**Heckmondwike Bus Station** *(part of the Transforming Cities Fund programme)*

**APPENDIX A - VER 1 Kirklees Road Safety Audit Procedures – SPD – Internal Audits**

## **ROAD SAFETY AUDIT PROBLEMS**

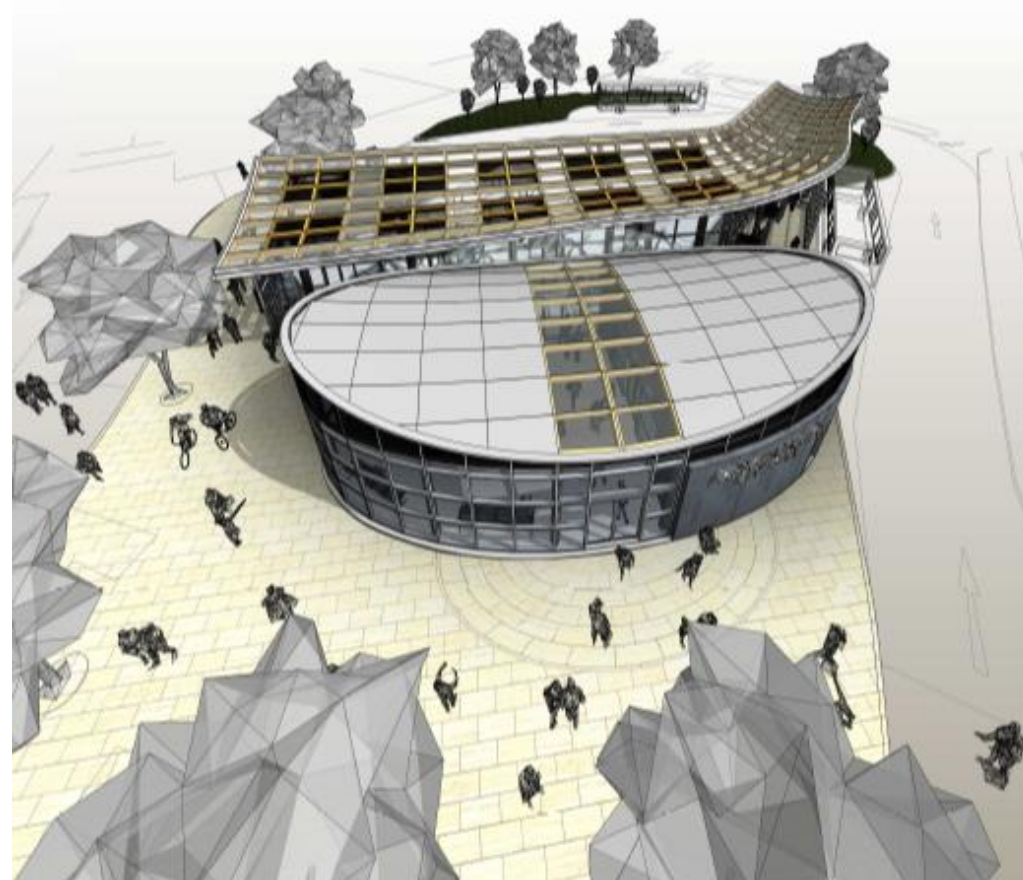
As part of the Transforming Cities Fund programme, (see adjacent concept design) a transformational bus station is proposed for the current Heckmondwike Bus Hub.
